## HISTORIC PRESERVATION BOARD STAFF REPORT

53 SE 7th Avenue

September 2, 2020

2019-212

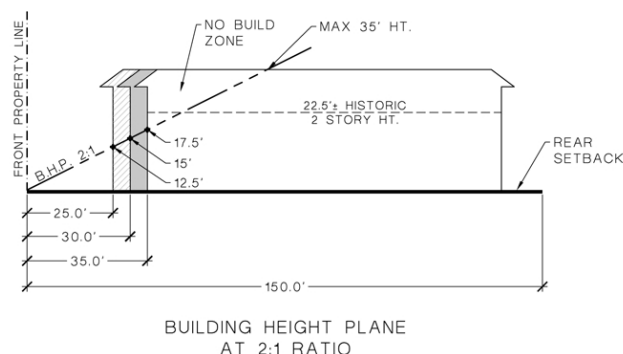
Pursuant to LDR Section 4.5.1.(E)(7)(a), *Height*. The height of proposed buildings or modifications shall be visually compatible in comparison or relation to the height of existing structures and buildings in a historic district for all major and minor development. For major development, visual compatibility with respect to the height of residential structures, as defined by 4.5.1(E)(2)(a) shall also be determined through application of the following:

**Building Height Plane (BHP):** The building height plane technique sets back the overall height of a building from the front property line.

- a. The building height plane line is extended at an inclined angle from the intersection of the front yard property line and the average grade of the adjacent street along the lot frontage. The inclined angle shall be established at a two to one (2:1) ratio. See illustration below.

The subject waiver request is to permit the front elevation of the proposed structure to extend into the "No Build Zone", above the permitted 2:1 Building Height Plane requirement.
